Addendum 47 – UN Regulation No. 48

Revision 10 - Amendment 8

Supplement 21 to the 04 series of amendments – Date of entry into force: 4 January 2023

Uniform provisions concerning the approval of vehicles with regard to the installation of lighting and light-signalling devices

"Annex 4

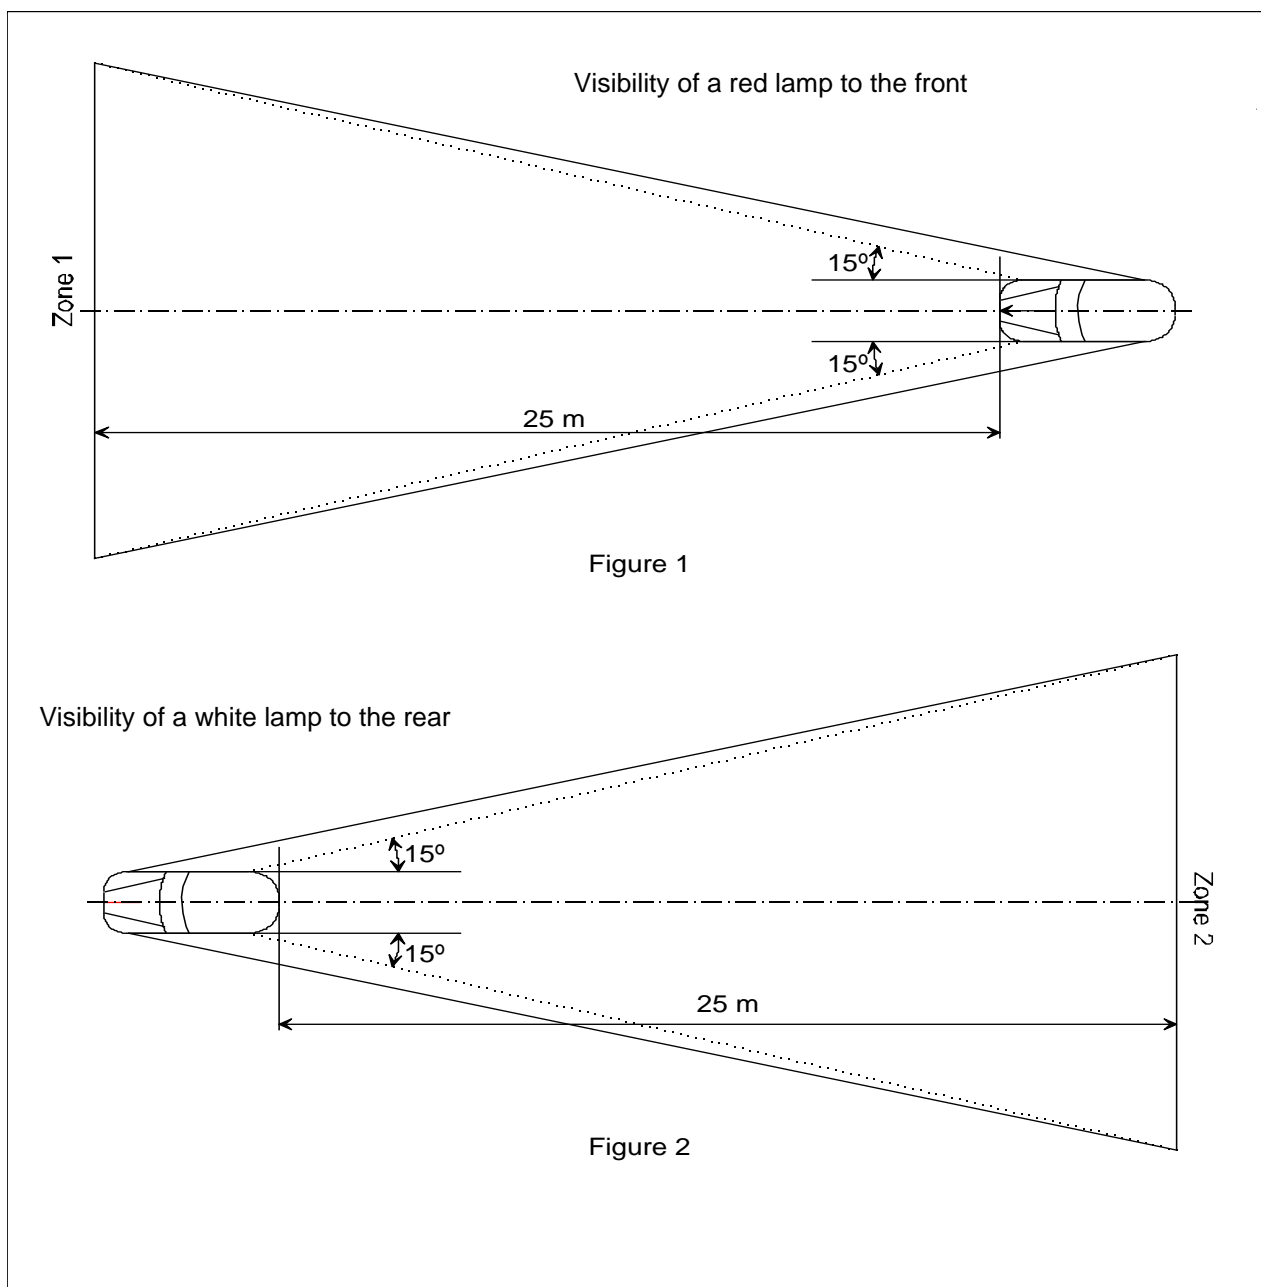
Annex 4, amend to read:

Visibility of a red lamp to the front and visibility of a white lamp to the rear

(See paragraph 5.10.4. of this Regulation)

In their respective planes, the zones 1 and 2 explored by the eye of the observer are bounded:

- In height, by two horizontal planes 1 m and 2.2 m respectively above the ground;
 - In width, by two vertical planes which, forming to the front and to the rear respectively an angle of 15° outwards from the vehicle's median longitudinal plane, pass through the point or points of contact of vertical planes parallel to the vehicle's median longitudinal plane delimiting the vehicle's overall width; if there are several points of contact, the foremost shall correspond to the forward plane and the rearmost to the rearward plane."
-
